Request for Proposal (RFP)

Addendum No. 2

Project Name: N5012(1)1,2&4 Road Improvement Project in Sanostee, NM

Owner: Navajo Division of Transportation

STRUCTURE PLACEMENTS

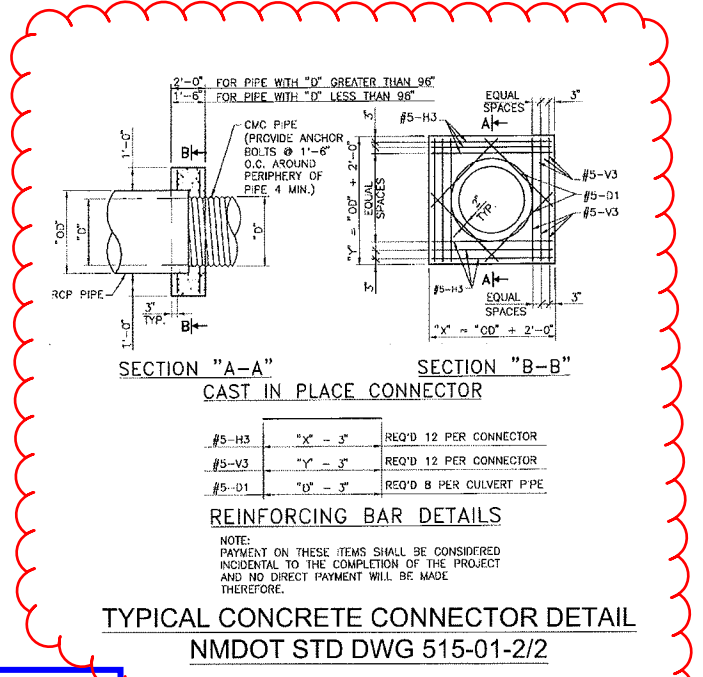
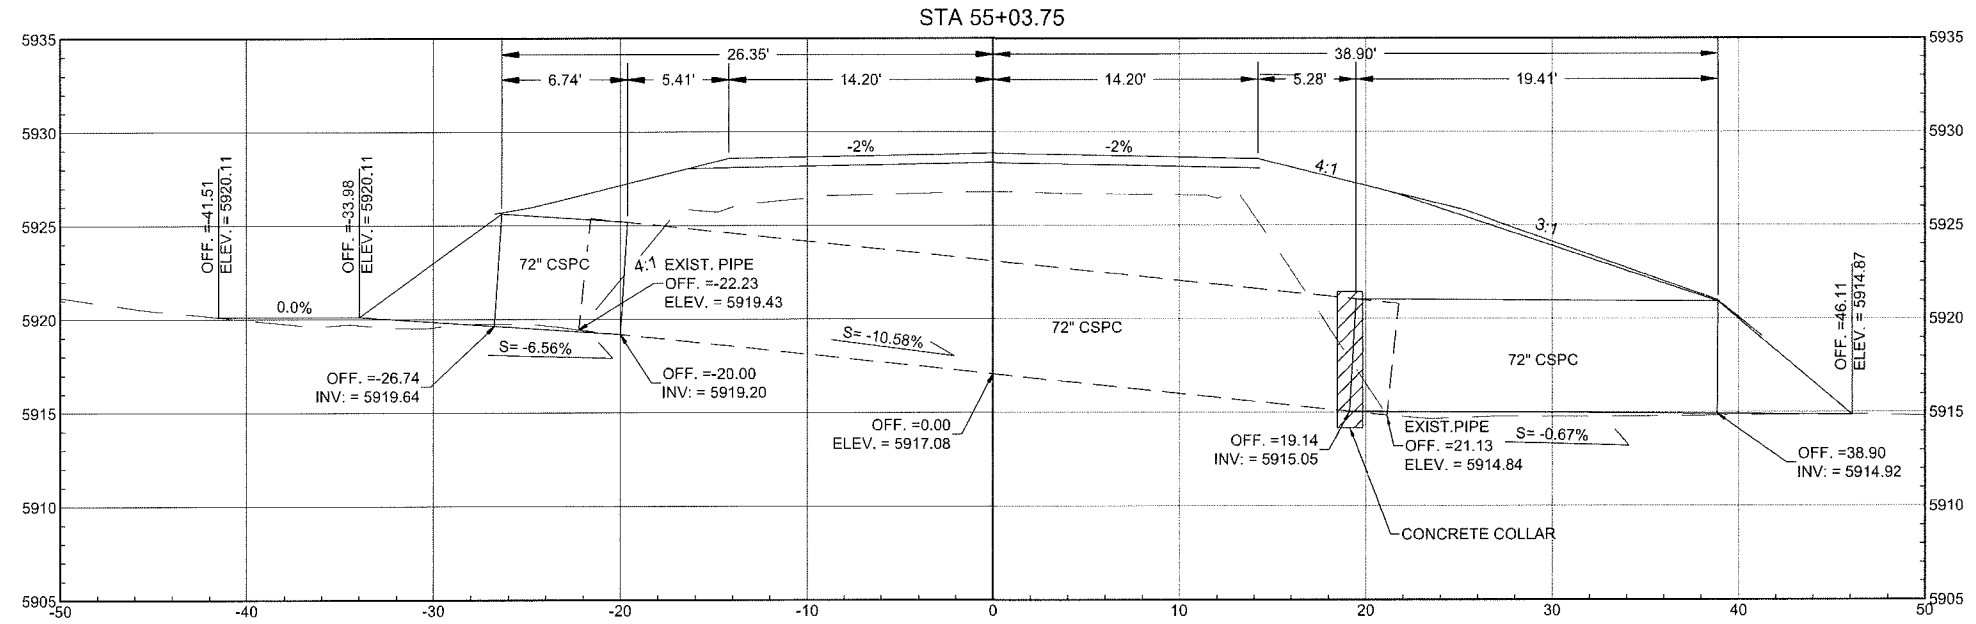
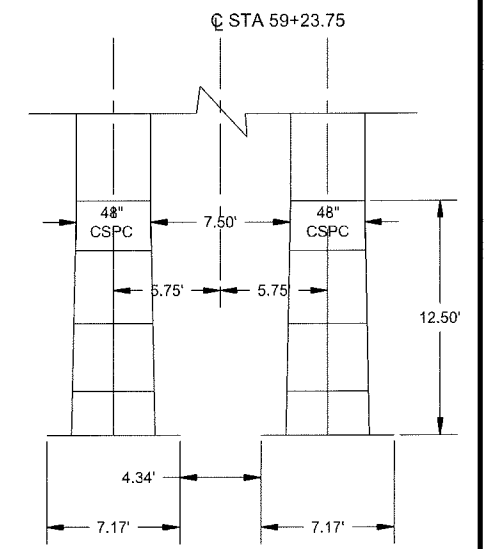
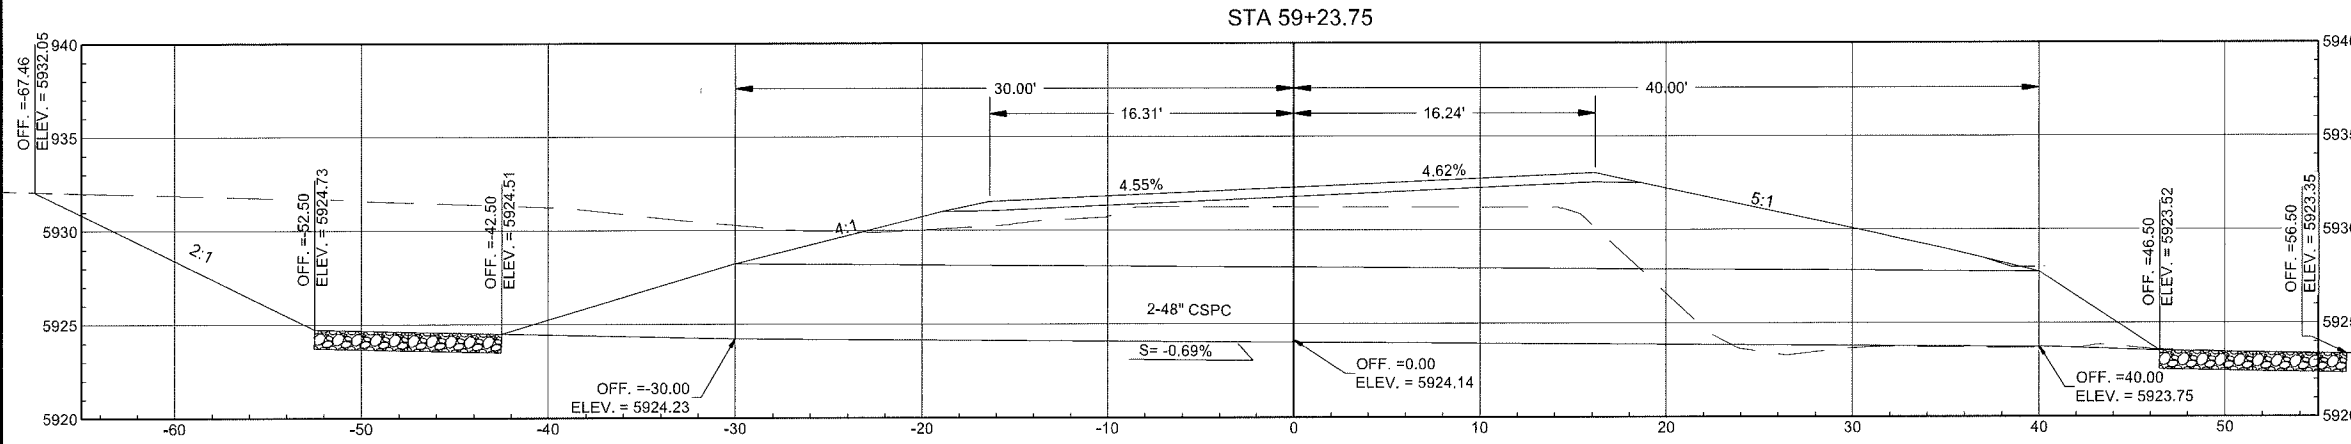
1. Revisions to the SF-1442 form in the Contract Book were made, the attached SF-1442 form shall replace the original form.
2. Sheet 38 of the N5012(1) plans has been revised. Revisions include adding a concrete connector detail.
3. The Navajo Division of Transportation has received the following question regarding this RFP and thereby issues the following response:

Question Submitted	Response Provided
On form 1442 has a bid due date of 12/03/2021, should the contractor to correct the form with the correct bid date of 09/02/2021? Thank you for your time.	The SF-1442 Form has been updated and is attached to this addendum.
On sheet 38/75, the culvert profile for STA 55+03.57 calls out for a concrete collar. Can you please provide a detail and information of what is required for this installation?	Please see the revised sheet 38 for the requested detail. Please note that the material and labor to complete the concrete connector detail are incidental to the 72" culvert pipe bid item and no separate measurement or payment will be made.

DS-02 STA 55+03.57
 EXISTING 72" CSCP SKEWED @ 10° LT FWD;
 SAWCUT & REMOVE 2 LF OF CSCP LT & RT
 CONNECT TO EXISTING 72" CSCP LT & RT AND PROVIDE CONCRETE COLLAR AT 19.5' RT
 EXTEND LT w/72"x6.74' CSCP SKEWED @ 10° LT FWD;
 EXTEND RT w/72"x19.41' CSCP SKEWED @ 10° LT FWD;
 BUILD METAL END SECTIONS LT & RT
 FOR CONCRETE COLLAR CONNECTION, REFER TO NMDOT STD DWG 515-01-2/2, DETAIL
 SHOWN ON THIS SHEET.
